**IB12-N-001C**

**NO CRANK/NO START, NO SCAN TOOL COMMUNICATION – EXTREME  
COLD WEATHER**

- 2007-2015MY Isuzu N-Series  
Equipped with 5.2L (4HK1) Diesel Engine and Diesel Particulate Filter (DPF)

***This bulletin supersedes IB12-N-001B. This bulletin is being revised to update ambient temperature information. Please discard bulletin IB12-N-001B.***

**Figure 1** – Locate X-30 relay and relay cover rib

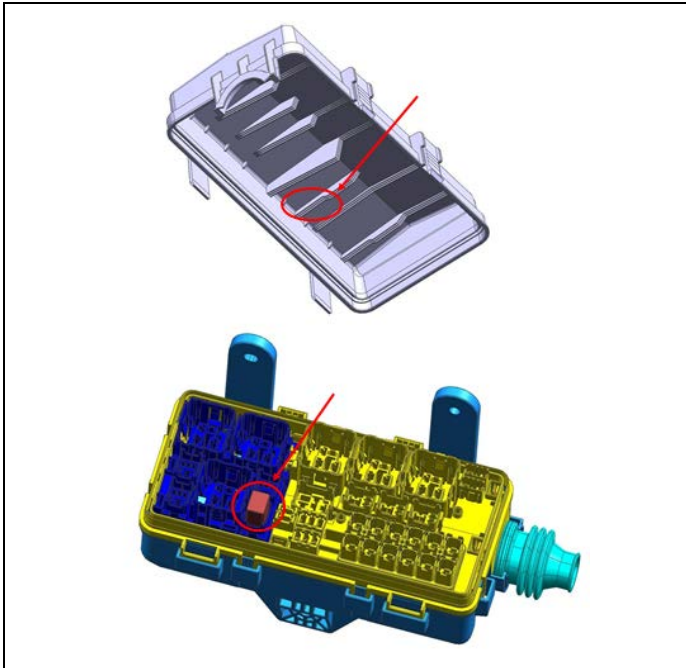
1. Remove relay box cover.
2. Remove the original ECM Main Relay in location X-30.
3. Install the new relay at location X-30.
4. Locate the relay box cover rib as shown in Figure 1.

**Figure 2** – Cut at dashed line

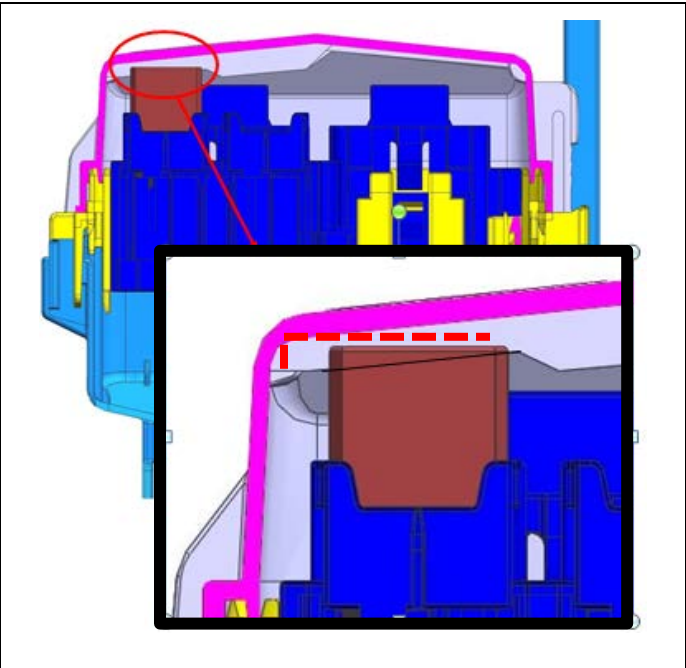
5. Trim the relay cover rib approximately 3mm to provide clearance for the new relay.
6. Install the relay cover and confirm it seals properly. If the cover does not close properly, trim additional material from the cover until it seals.
